LEGAL NAME OF PROJECT LLC

NOT FOR CONSTRUCTION SHEET TITLE CONCEPT-1 SHEET 1 of 1

SECTION A-A' - FRAME SIDE VIEW

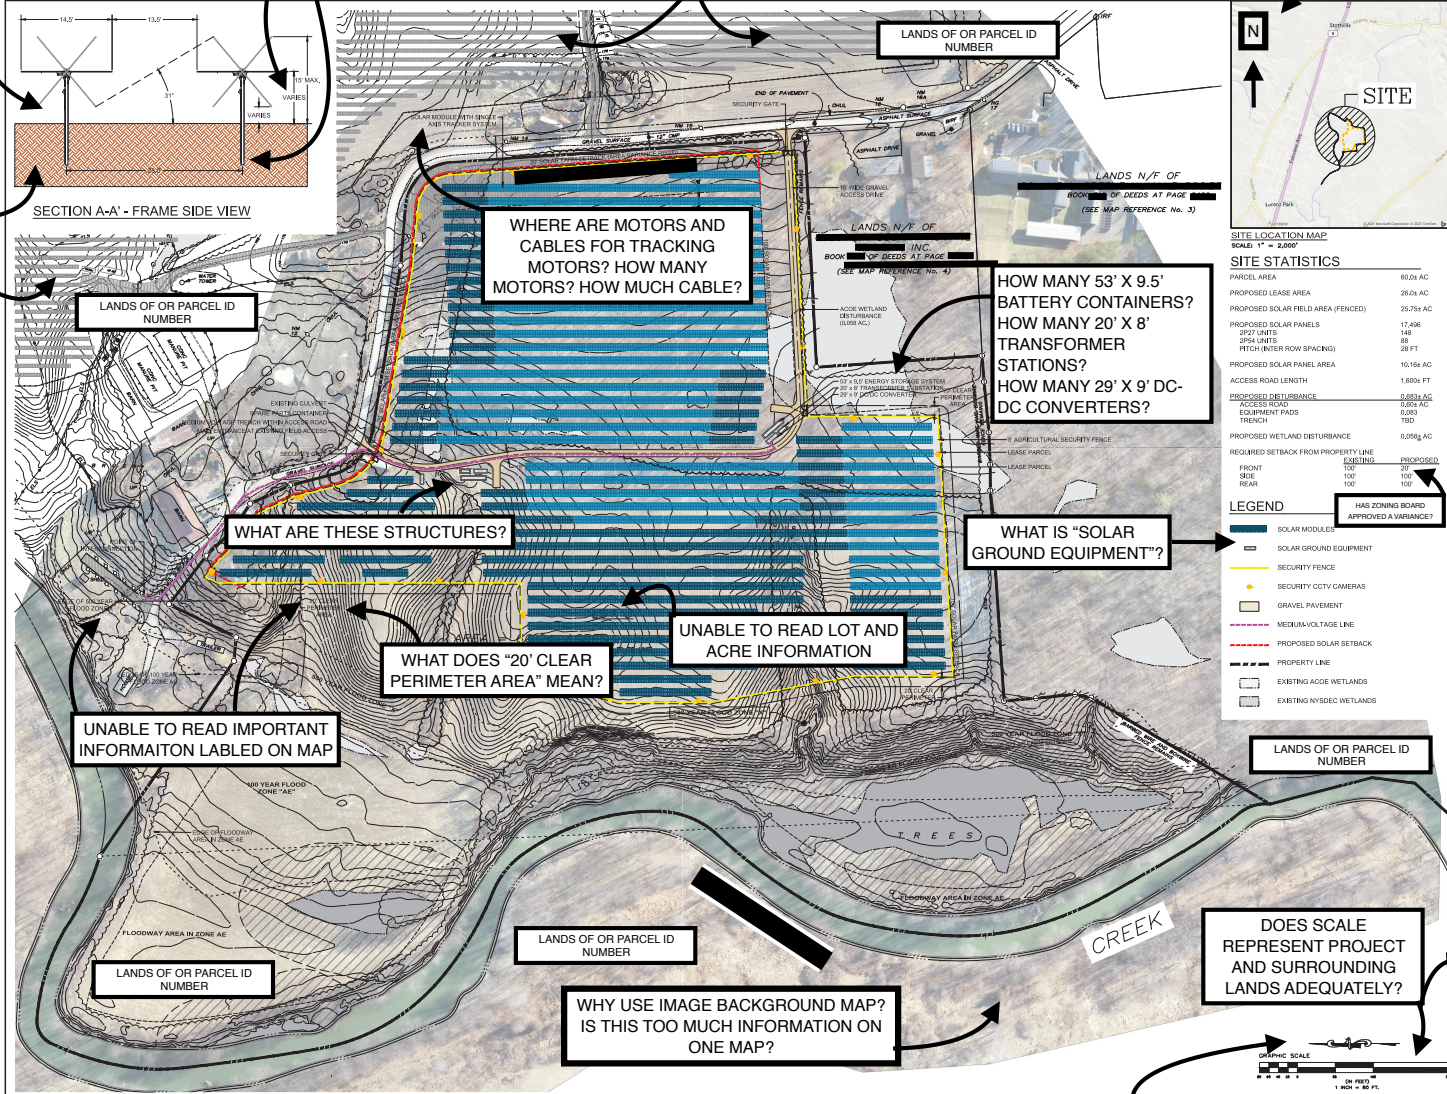
WHAT IS MAXIMUM HEIGHT OF SOLAR PANELS WHEN STORED FLAT PARALLEL TO GROUND?

WHAT IS DEPTH OF POSTS?

WHAT IS MINIMUM HEIGHT OF SOLAR PANELS TILTED TO GROUND?

IS THIS DETAIL OF TRACKING SOLAR PANELS COVERING UP SOMETHING THAT SHOULD BE CONSIDERED? REVIEW SATELLITE IMAGES TO LEARN MORE. PERFORM A SITE VISIT.

WHERE ARE MOTORS AND CABLES FOR TRACKING MOTORS? HOW MANY MOTORS? HOW MUCH CABLE?
